STAFF REPORT
KETCHUM PLANNING AND ZONING COMMISSION
MEETING OF AUGUST 11, 2020

PROJECT: 4th & Walnut Ave Commercial Development Design Review

FILE NUMBER: P20-046

APPLICATION TYPE: Design Review

ARCHITECTURAL SITE PLAN

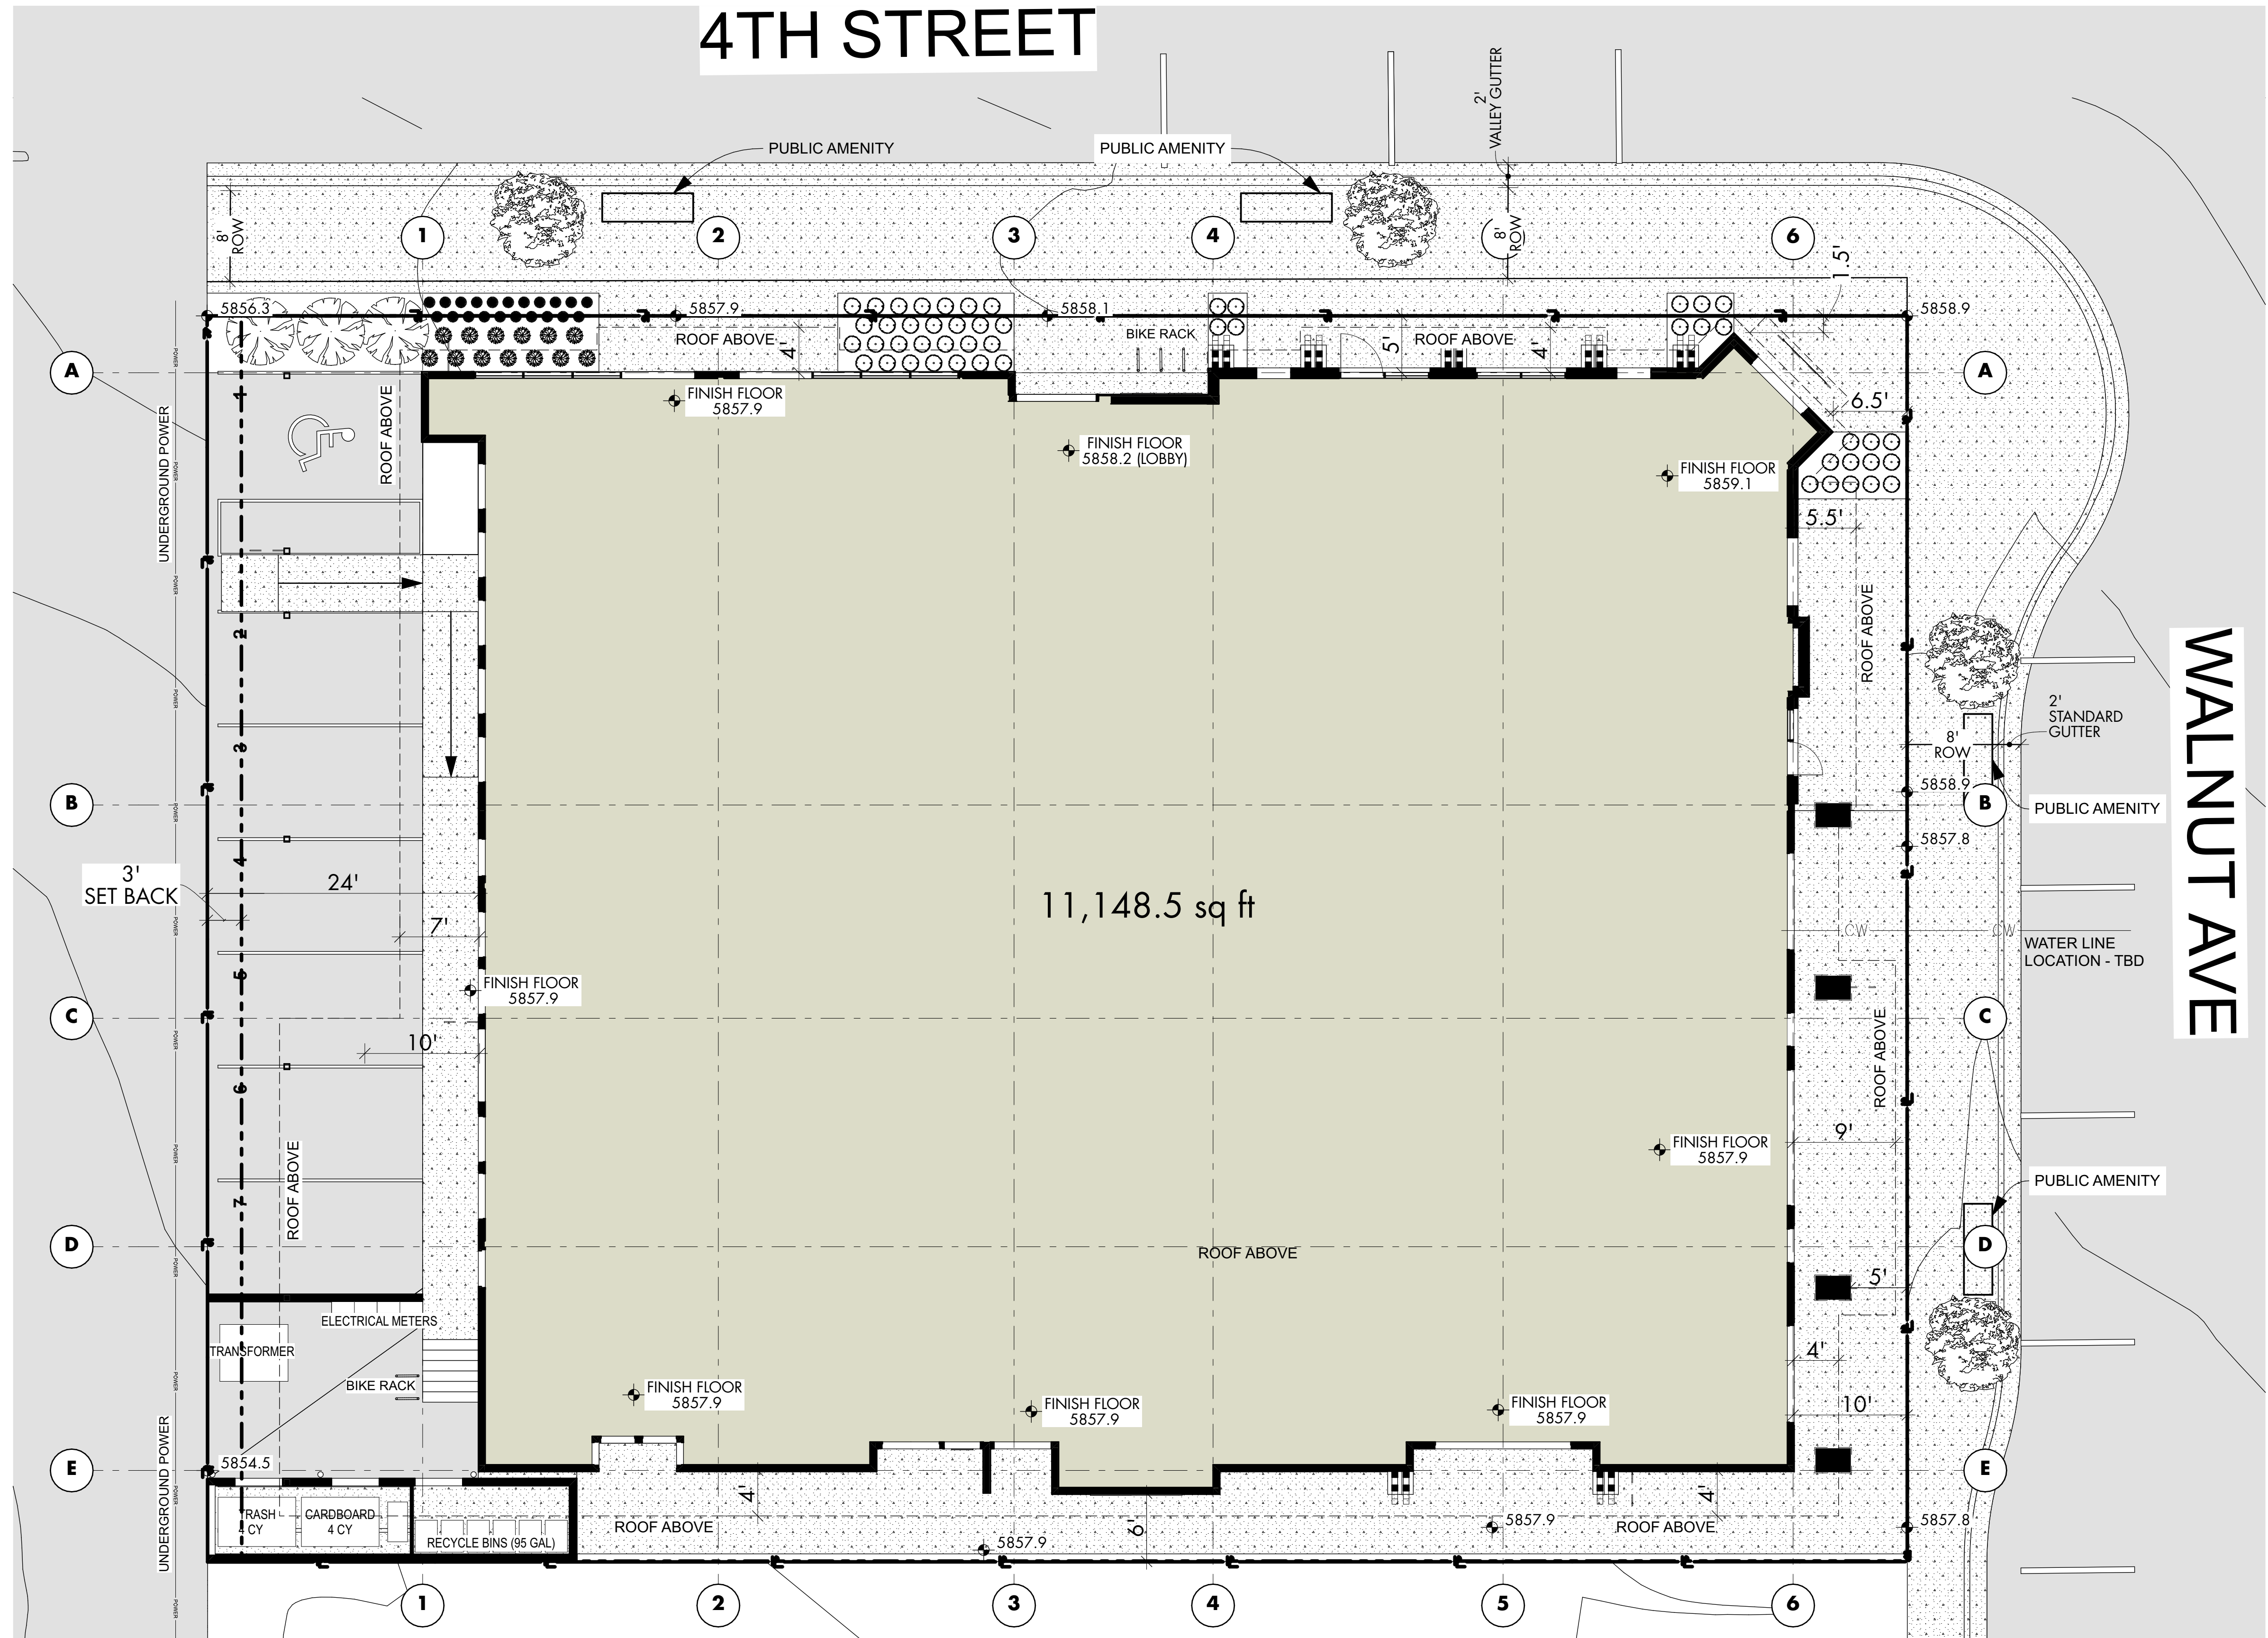
Two benches along 4th Street have been added to the architectural site plan (Sheet AS-101). The site plan notes that benches, trash receptacles, and art are anticipated to be provided with the project. The applicant will coordinate with the City Engineer, Streets Department, and Planning Department to determine the final location of all public amenities associated with the project.

1 NW Elevation (4th)
SCALE: 1/8" = 1'-0"

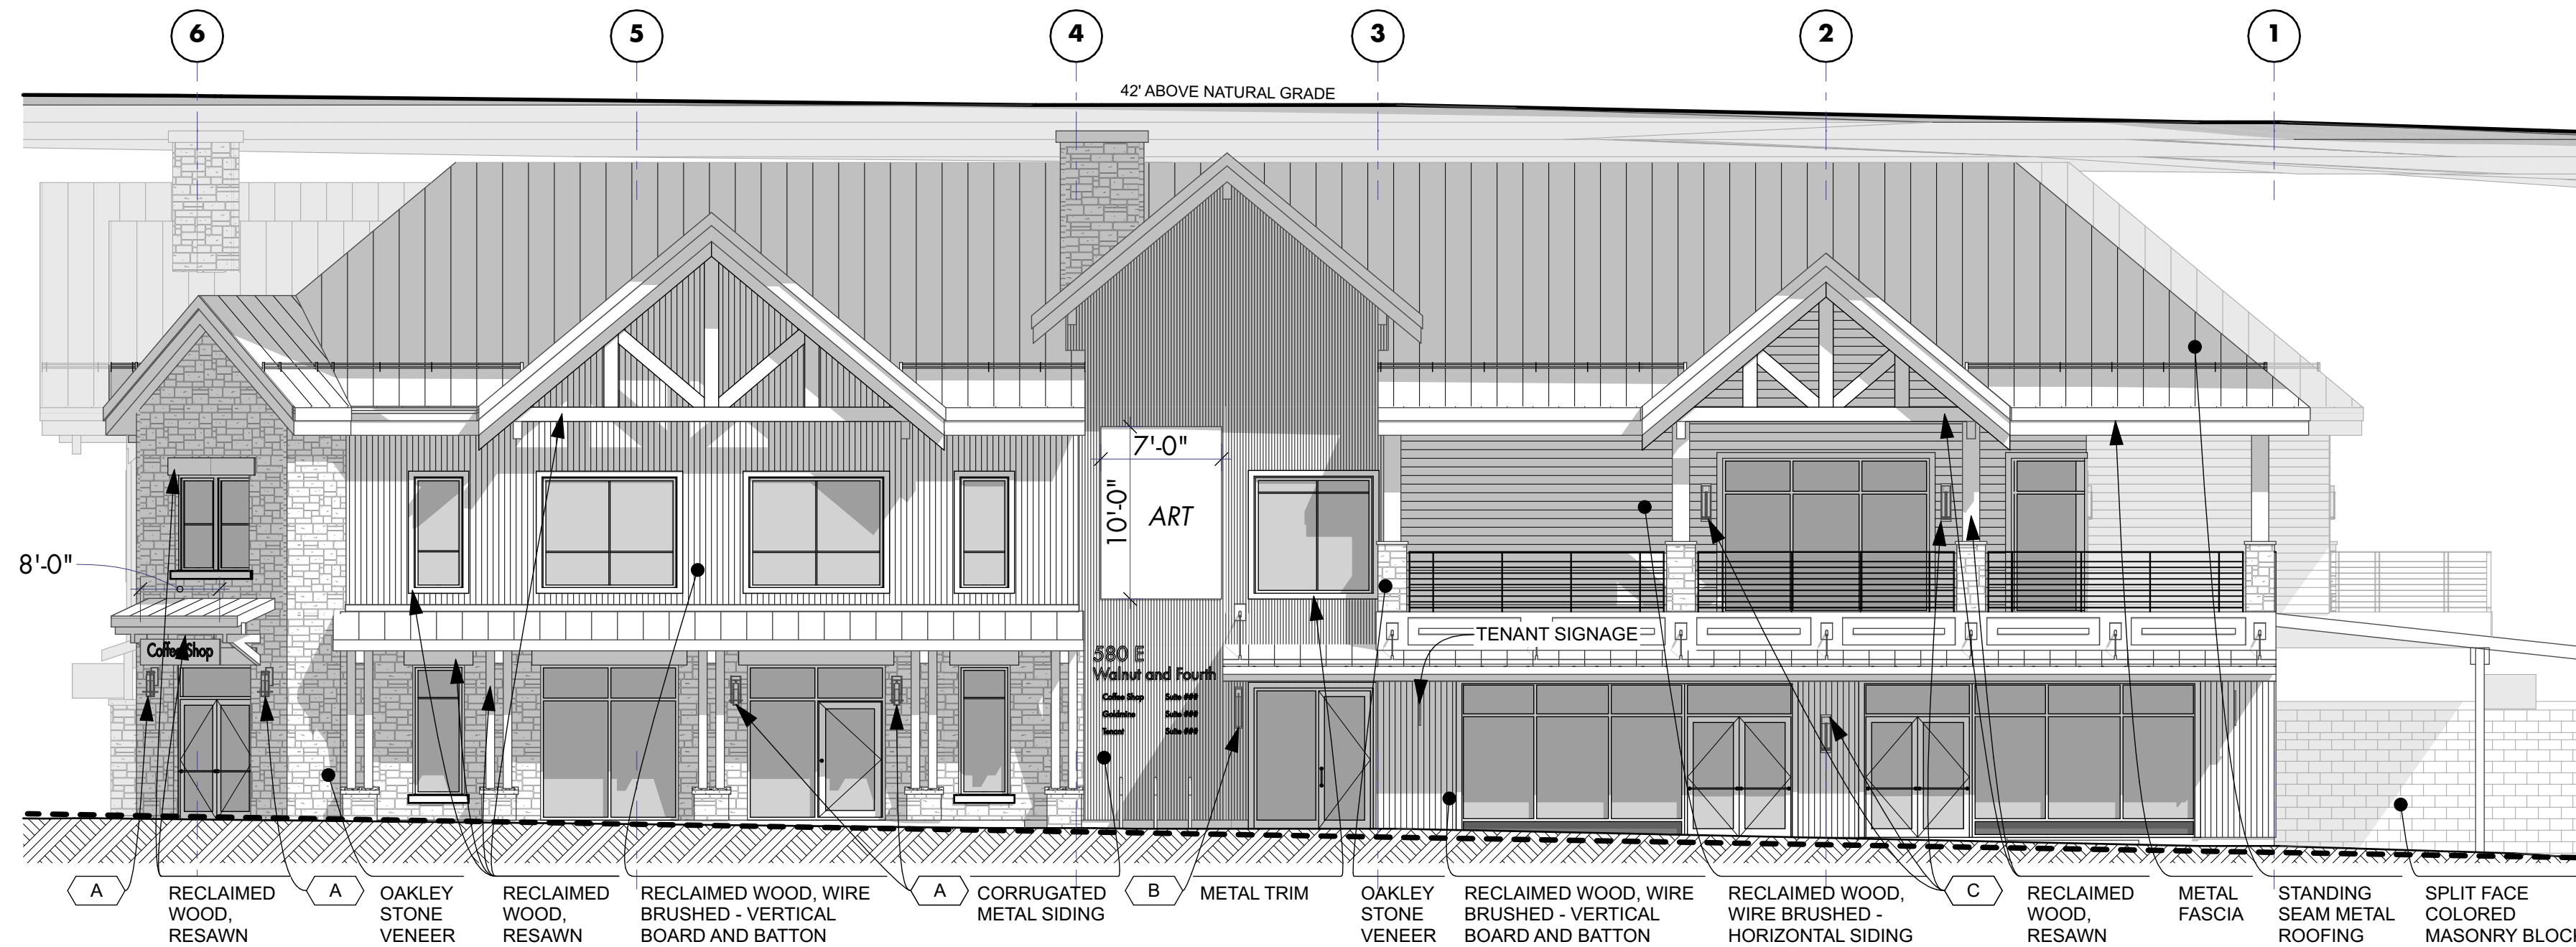
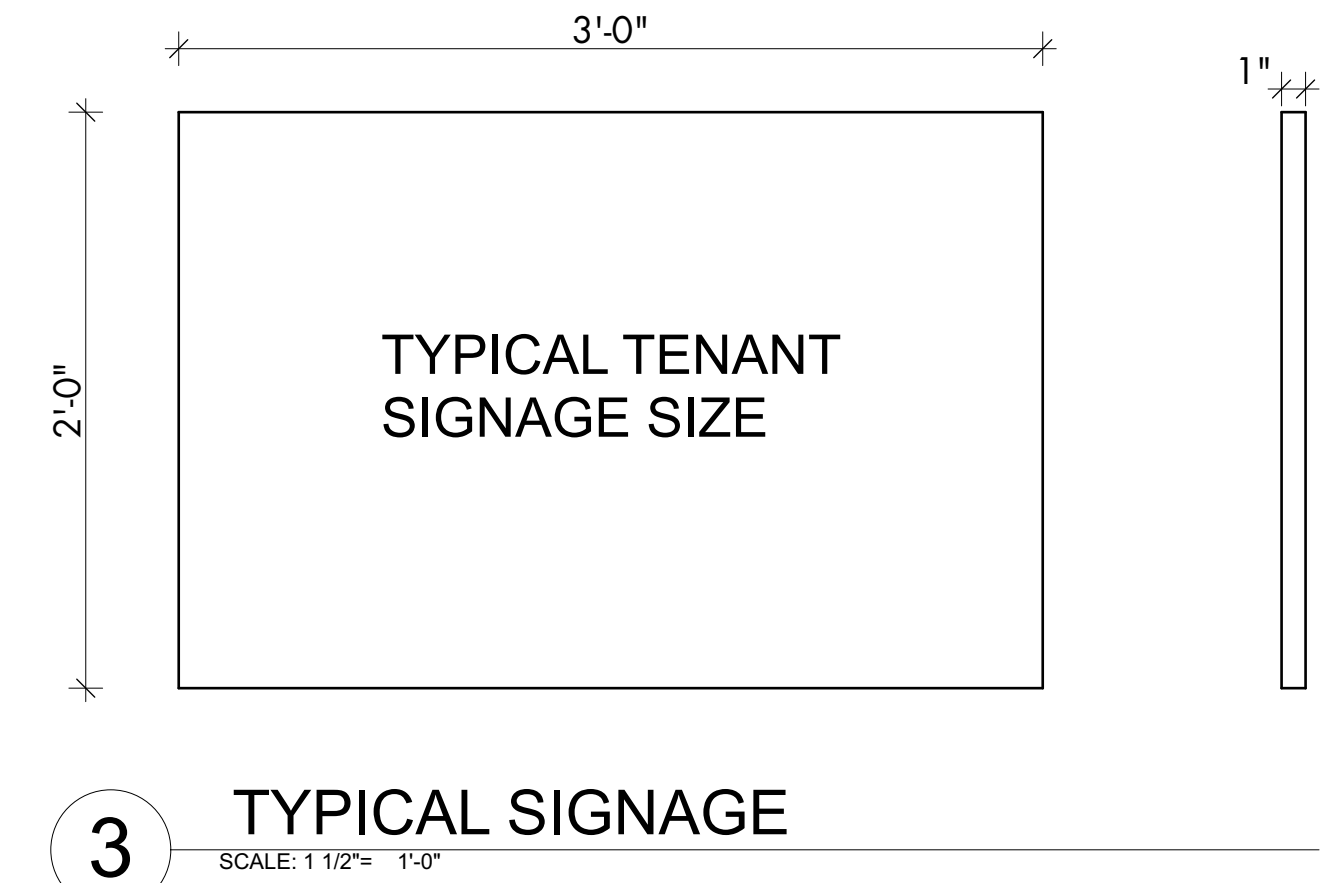
The applicant has annotated the elevations (Sheets A-201 & A-202) to specify the proposed exterior materials. The applicant has included additional renderings in the updated project plans. A link to a video illustrating the project from all elevations is attached to the Staff Report as Exhibit B.

1 SE Elevation
SCALE: 1/8" = 1'-0"

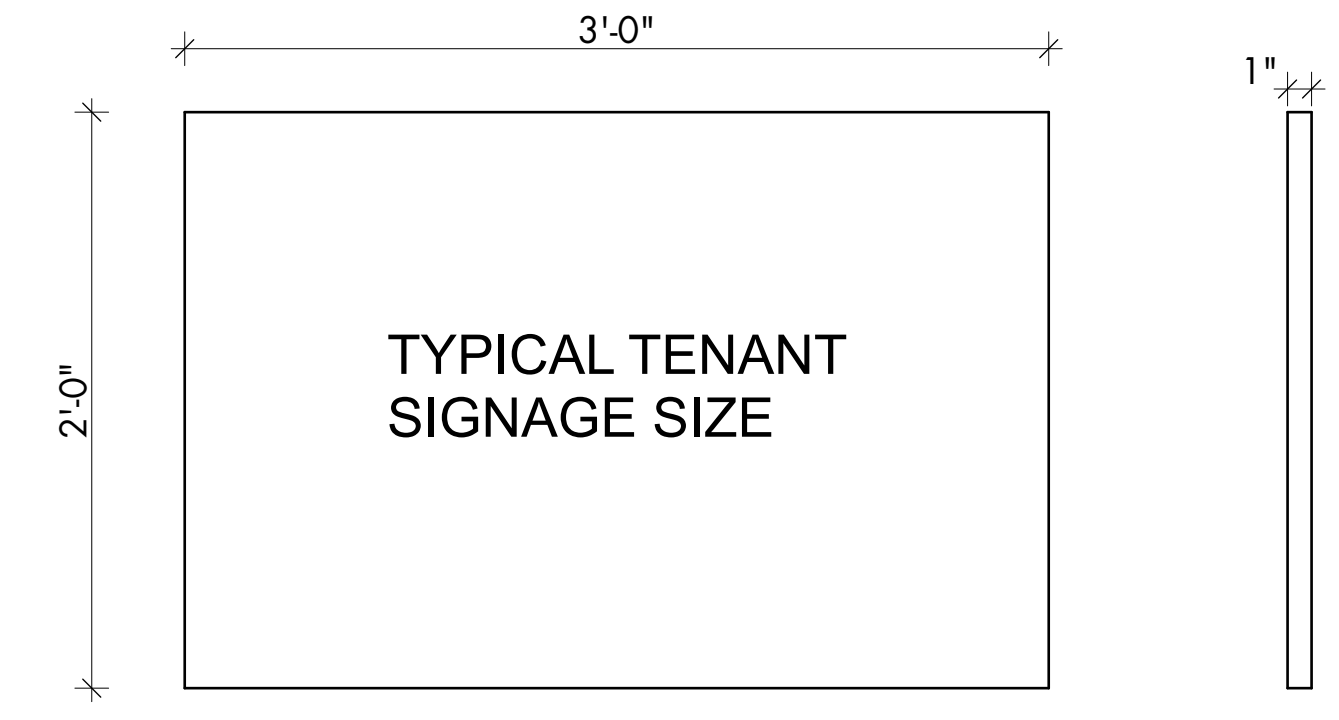
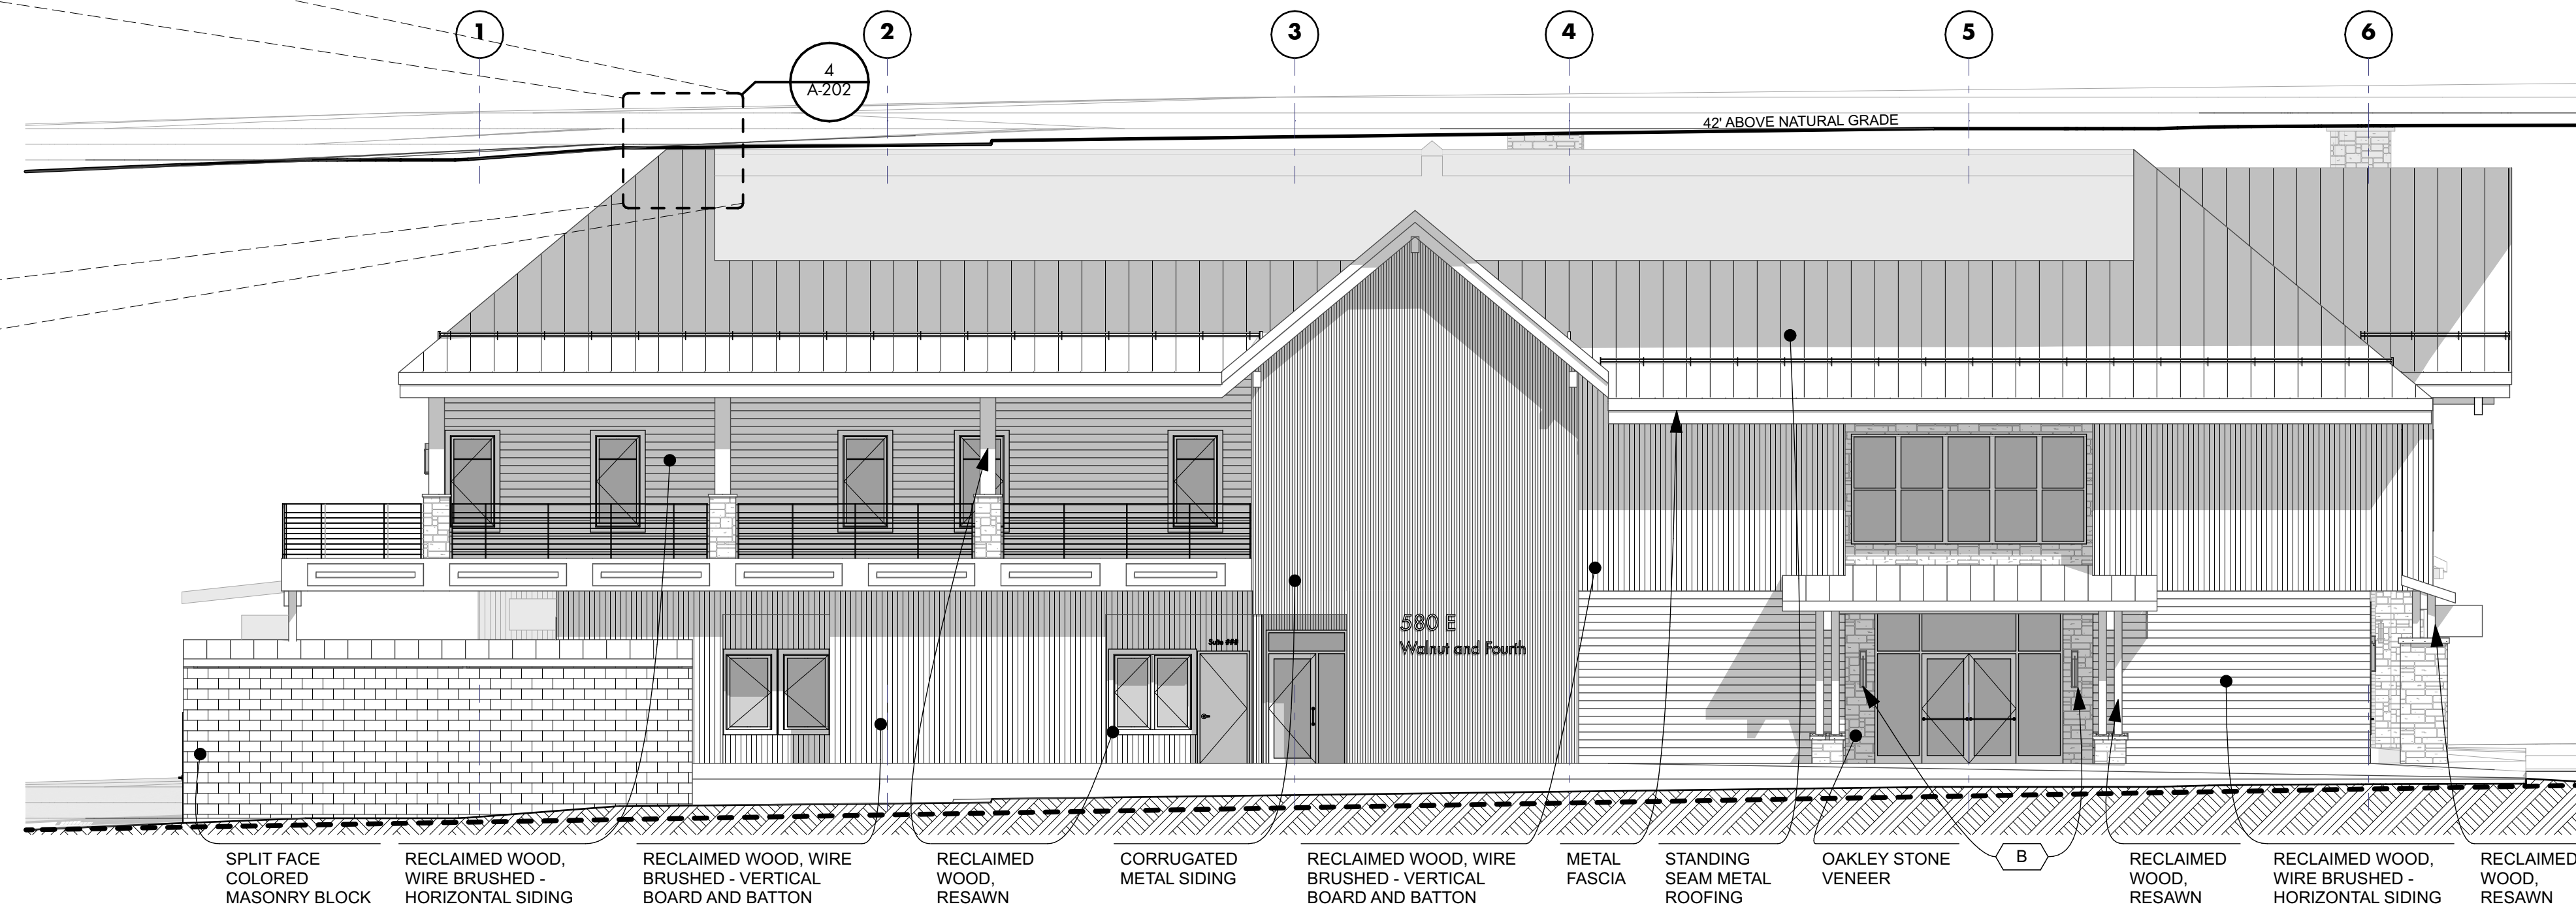
Staff Comments	<i>The proposed roof is a false mansard. As illustrated on the southeast elevation indicated on Sheet A-202, the top of the mansard roof falls into a 10-foot deep recessed area that is fully screened from public view. All roof-mounted mechanical, plumbing, and electrical</i>
